Exhibit “A”

HYBRID HEATING - COMPLETENESS REVIEW RESPONSE

RE: Completeness Review Response for Hybrid Heating Site Design Review

Request: A Type III Site Design Review (**DR-17-22**) application to redevelop a commercially zoned property by building a new storage building for Hybrid Heating and Air Conditioning. The development will include a modification of an existing building to office space, adding a new indoor storage facility, a new parking and loading area, vehicular and pedestrian circulation, landscaping, and a water quality facility.

DRAWN BY: TDM
 DESIGN BY: TDM
 CHECKED BY: TDM
 SCALE: AS SHOWN
 JOB NO: KW0001
C7.1

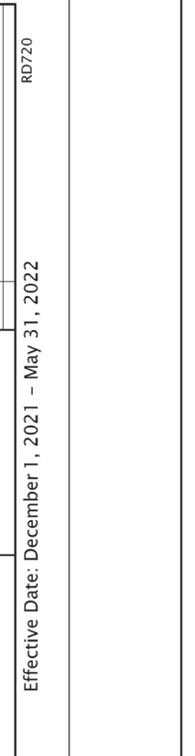
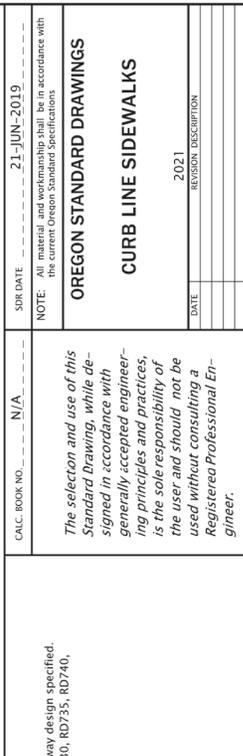
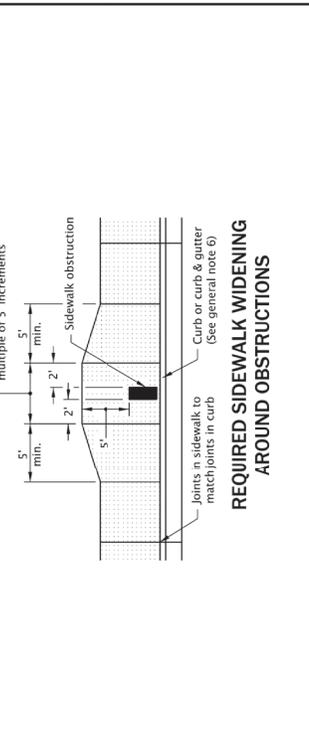
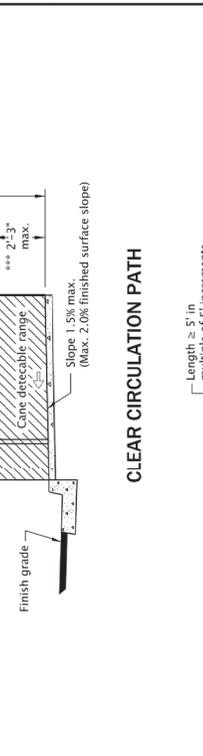
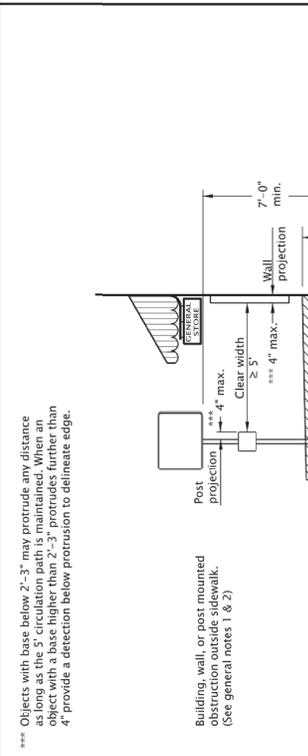
5. Provide a detail of the proposed trash enclosure with its dimensions.

7. Provide bicycle parking, along with a detail, per CMC 18.175 of the Parking Code.

RESPONSE: The trash enclosure detail is now shown on sheet C7.2.

RESPONSE: Bicycle parking is now shown on the Civil site plan, and a detail is included on Sheet C7.2.

LANDSCAPE PLAN
 1/8" = 1'-0"

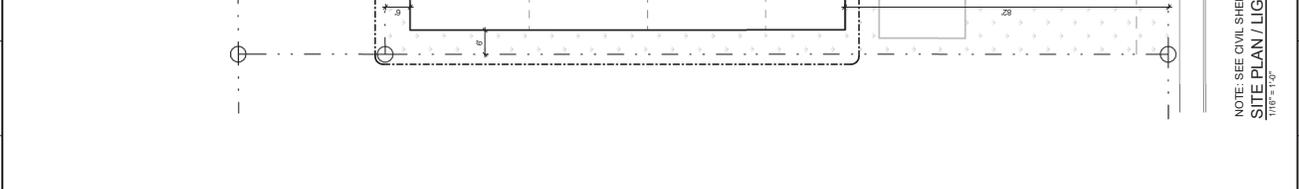
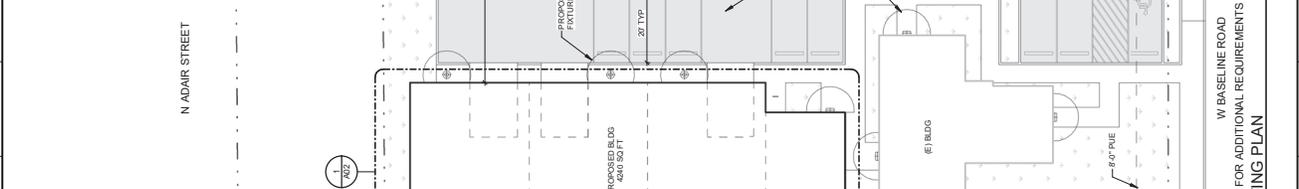
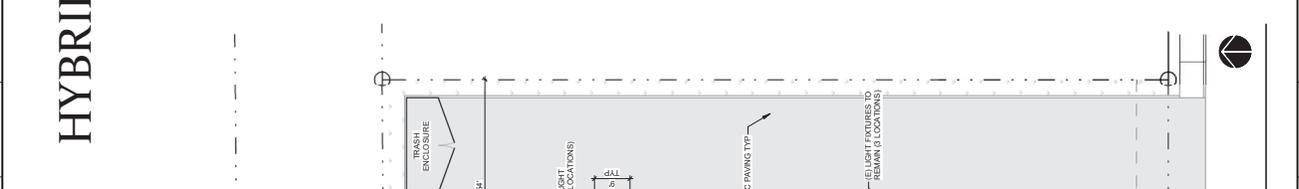
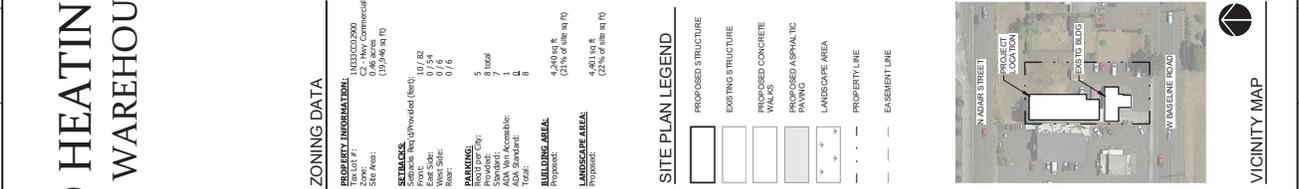
The preliminary engineering plans (Sheet C2.0) show these street trees, however, the landscaping plan does not show the required street trees.
